**AMENDMENT NO. 001; 04/27/15**RFP#: RB8-62BulkheadSite Name: Red and Bonita Mine SiteT.O.#: 0062Location: Silverton, COJob #: RB8-62Attachments: Yes No

Environmental Restoration, LLC (ER) is issuing Amendment 001 to provide answers to questions provided by bidders. The questions and answers are contained in Section 1. An additional scope of work involving provision of a PE-stamped ground Control Plan is described in Section 2. Following Section 2 are two attachments. Attachment 1 is a load diagram provided in response to question 12. Attachment 2 is a revised Schedule of Pricing that includes an additional line item for PE evaluation and development of a ground control plan (Section 2).

Section 1: Questions and Answers

ATTACHMENT 1: LOAD DIAGRAM

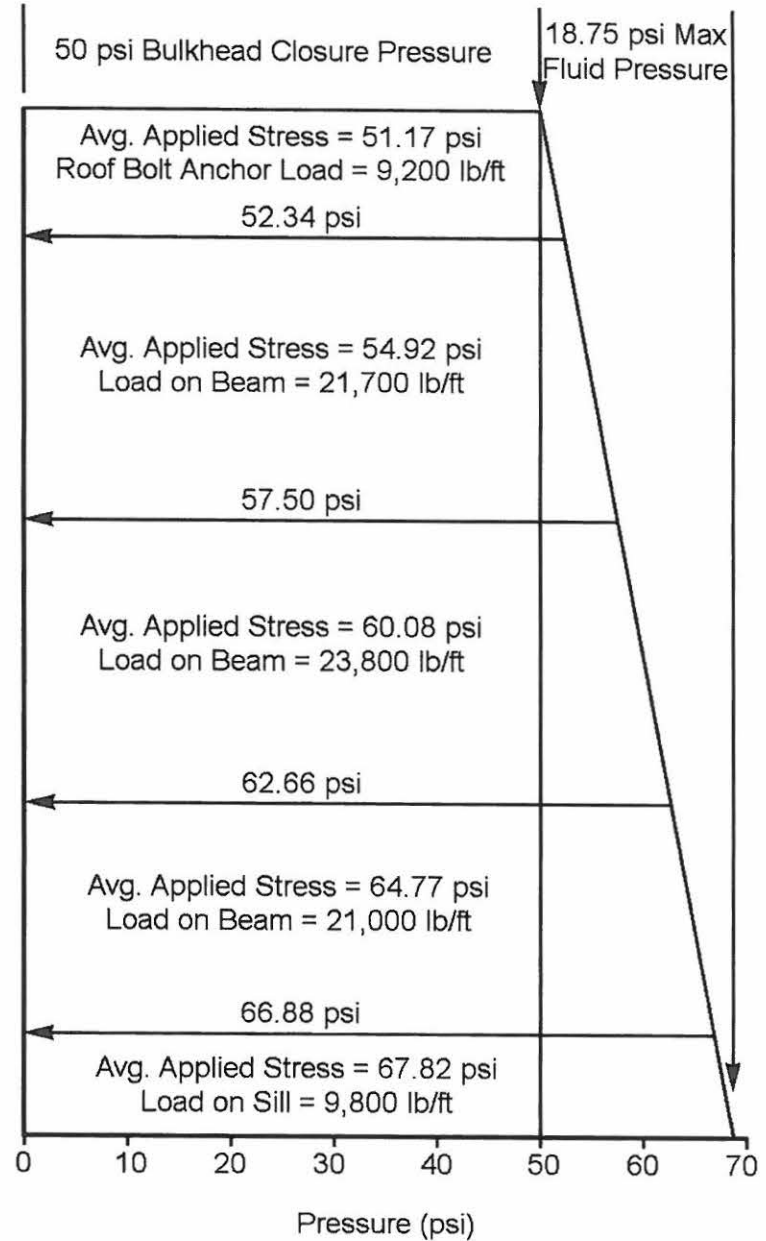
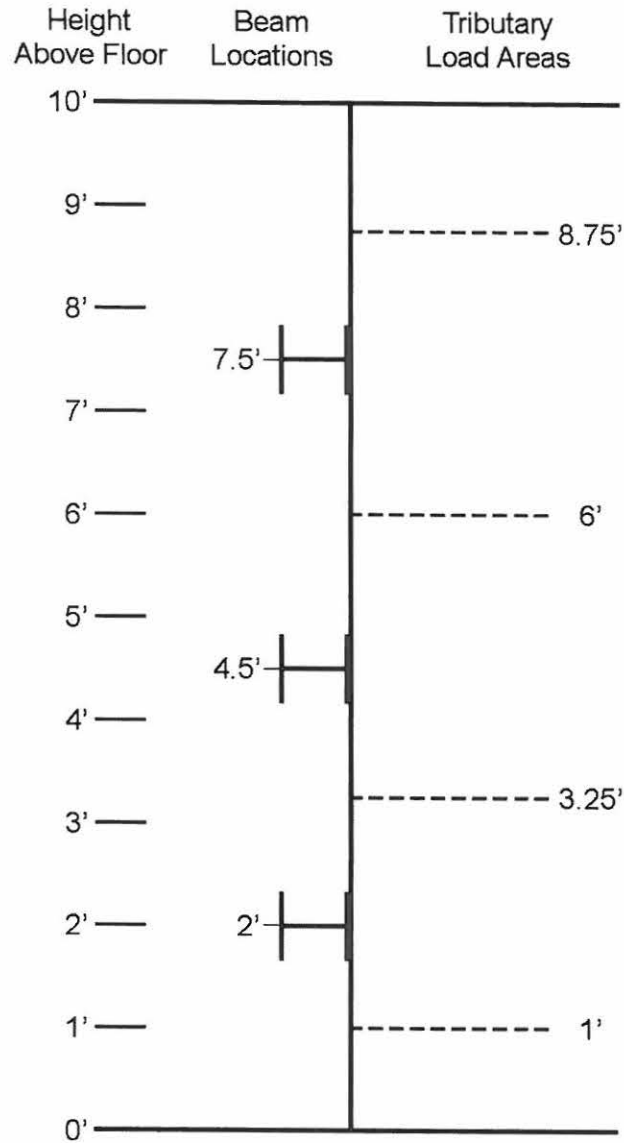
- What psi of total pressure (hydrostatic head of SCC mix plus final stroke pump overpressure) is the design rated for? **See Attachment 1.**
- Will ER take responsibility for failure of the forms if constructed according to plan?
